Safe, Clean Water Program Scoring Committee Meeting Minutes

Tuesday October 5, 2021 1:00 PM – 4:00 PM WebEx Meeting

Safe, Clean Water Program Scoring Rubric - Fiscal Year 2022-2023

Safe Clean Water Projects Module Jackson ES, Revised FS

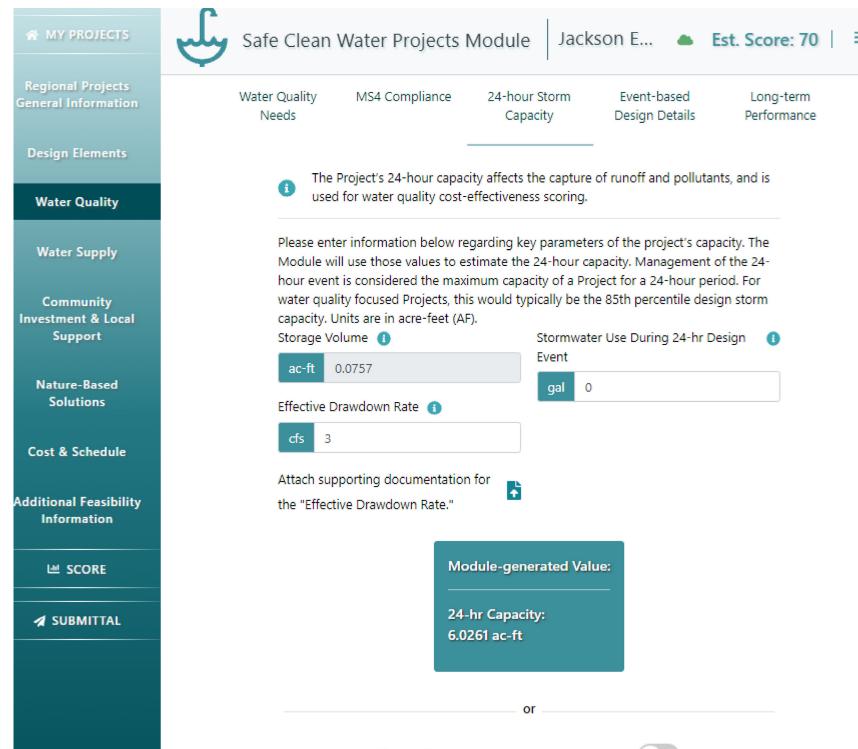
1. When entering parameters into the Module, the determination of infiltration well units (Section 2.1 Configuration) and stormwater use during 24-hour design event (Section 3.3 24-hour Storm Capacity) were incorrect. Based on the storage volume in each drywell, total infiltration well units should be 4.21, resulting in a storage capacity of 0.0757 acre-feet. An effective drawdown rate of 3.0cfs (0.3cfs/well x 10 wells), and 0.0 gallons of use during the event, results in a 6.03 acre-feet 24-hour BMP capacity.

2. Two numbers were transposed in Table 2 of the "Hydrology and Water Quality Analysis" as part of Attachments for Section 2.4. The total inflow volume during design event, which is entered into Section 3.4 of the Module, should be 2.0 acre-feet. Likewise, the peak inflow rate during design event should be 4.4cfs.

Attached are screenshots from the Module with the above corrections. With no change to the layout, design or modeling, applicant scoring remains the same at 70.
